# AP1000 DESIGN CERTIFICATION REVIEW

## Response to Request For Additional Information

Figure 720.049-1  
ULPU facility schematic

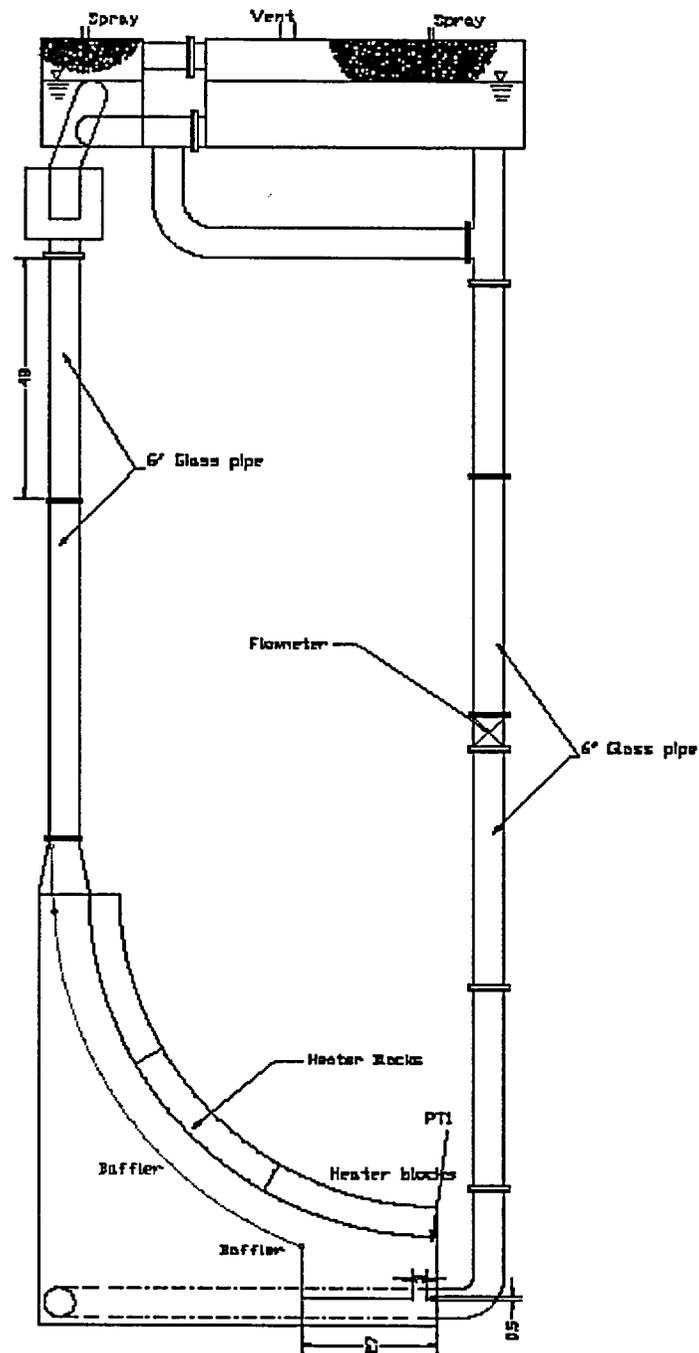
### **Question:**

The baffle in ULPU-2000 models a streamlined insulation that is shaped to closely follow the contour of the vessel lower head (see Figure 720.049-1). Different baffle positions are possible in ULPU-2000 to optimize the flowpath for a maximum critical heat flux. Three heater blocks (15 cm wide) represent the reactor vessel wall. At 90° angle, this 15 cm width corresponds to 1:84 of the AP-1000 vessel lower head circumference (d= 4m). Accordingly, cross-section areas of the riser and vent duct (that connect the riser to the nozzle gallery) are chosen to be 1:84 of the flow path area in the riser and vent duct of AP-1000. Furthermore, the vent duct is made to accommodate a flow area change from circumferential to 4 ducts and with an inclination that faithfully reflects the AP-1000 design (see Figure 720.049-2 of ULPU vent path design). Modifications were also made to faithfully represent the water inlet geometry (see Figure 720.049-3 of ULPU water inlet configuration).
